CITY OF NEWTON

LAND USE COMMITTEE REPORT

TUESDAY, JUNE 5, 2012

PERMIT #93-12

Proposed Basement:

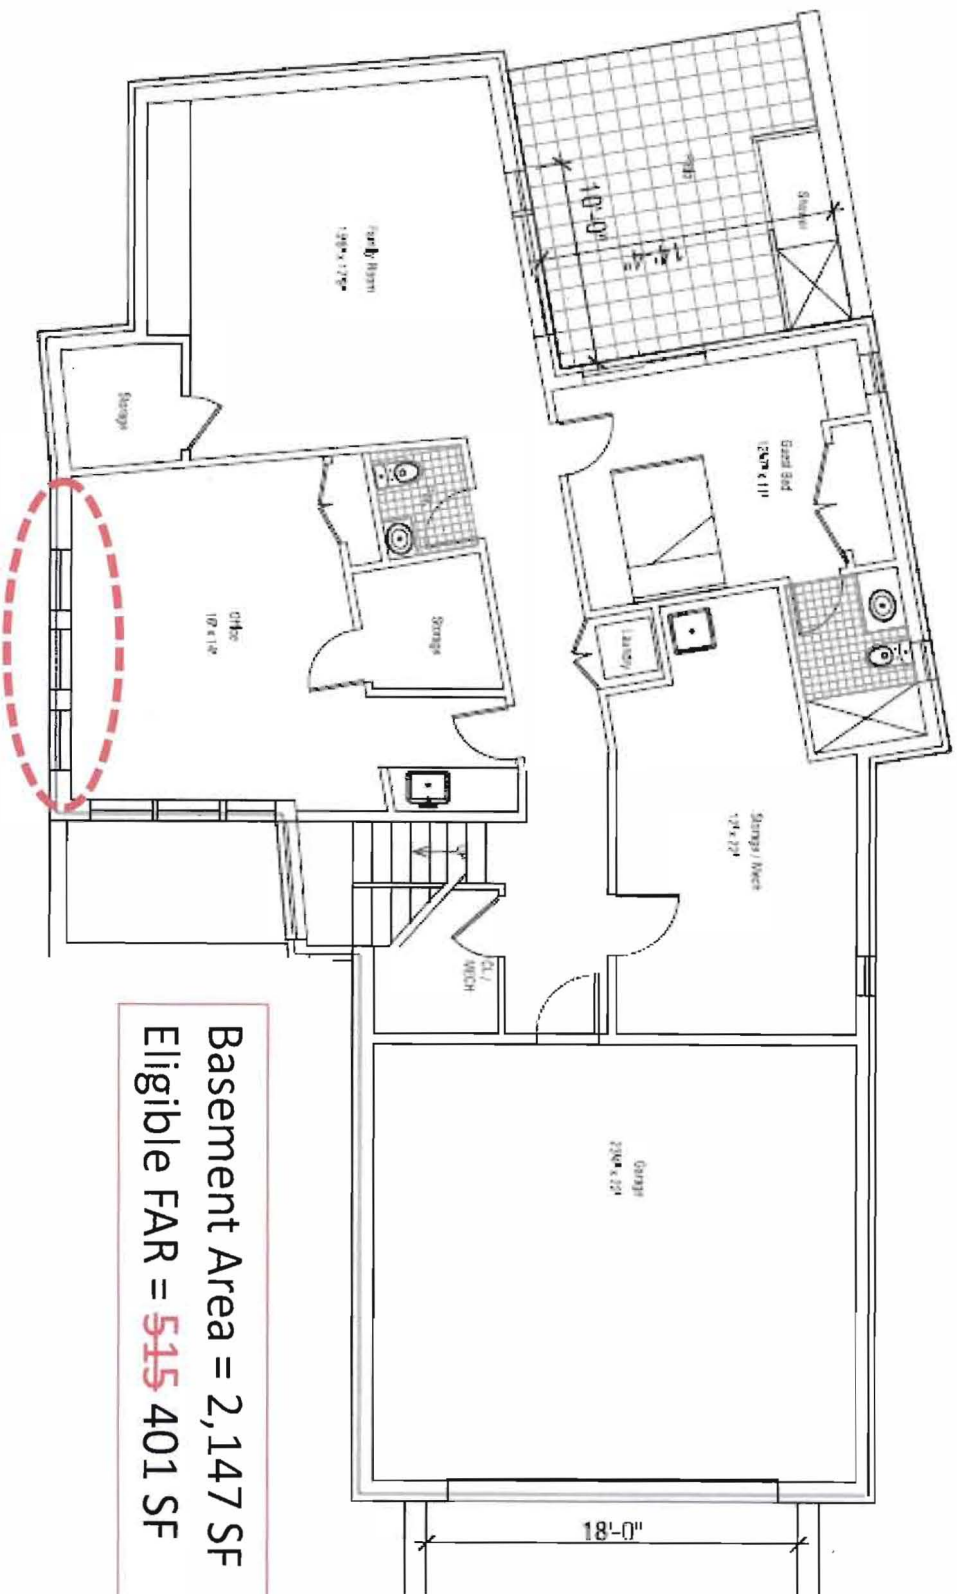
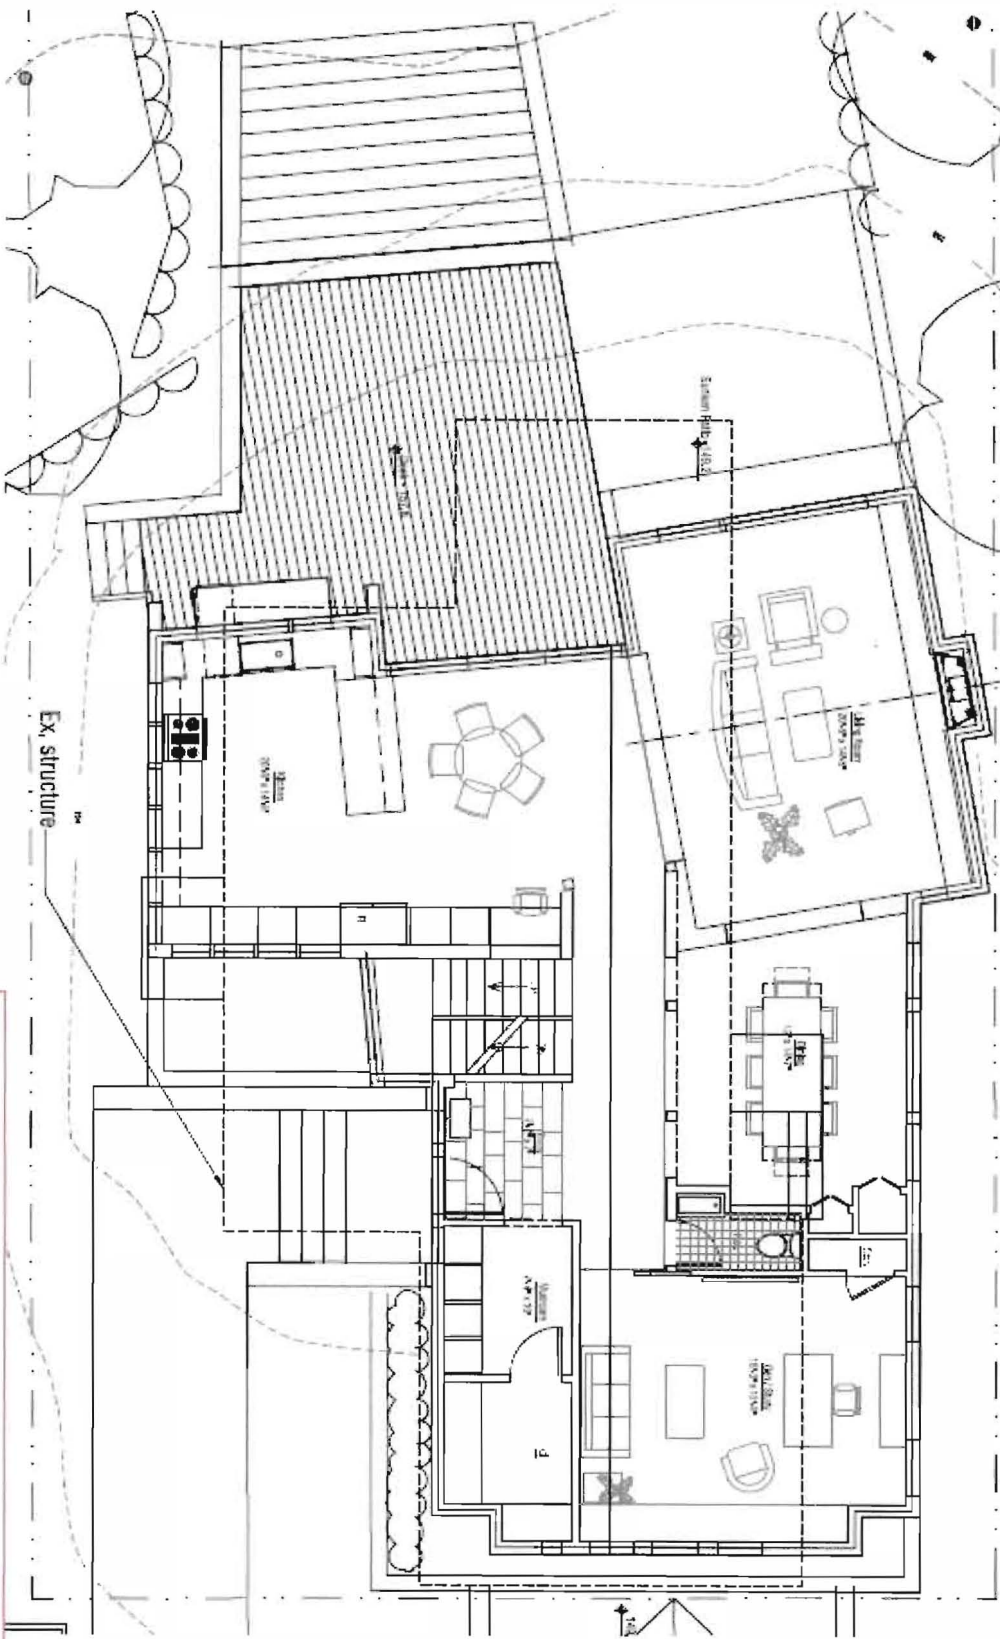
Basement Area = 2,147 SF
Eligible FAR = 515 401 SF

Proposed Third Floor:

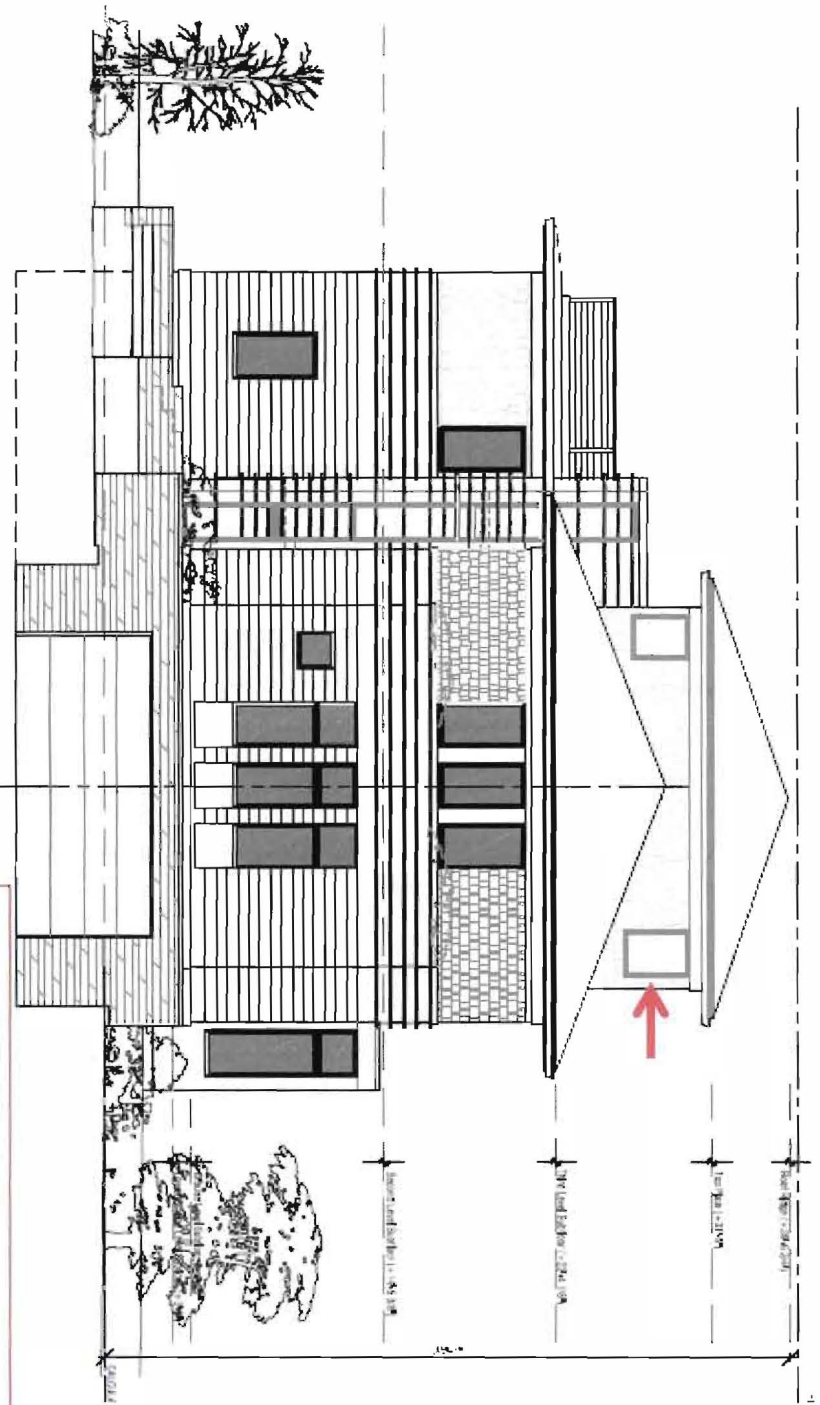
3rd Floor FAR Area = **538** 437
SF

Proposed Front Elevation:

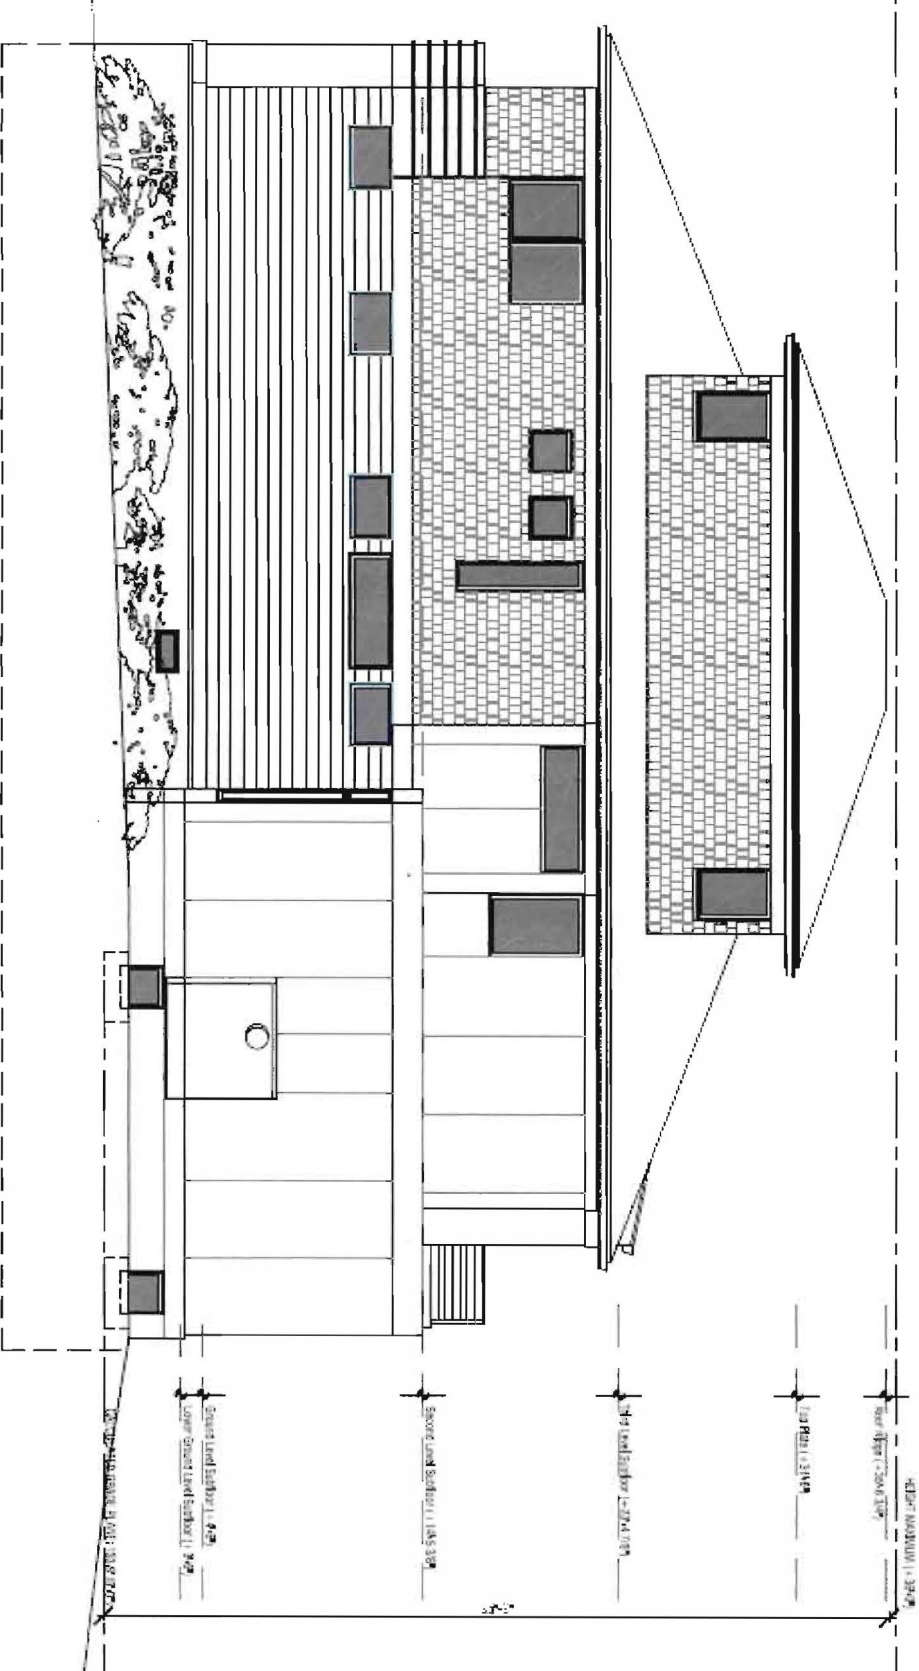
Raising house ~ 4 ft. to accommodate full basement
Height 35'-7"
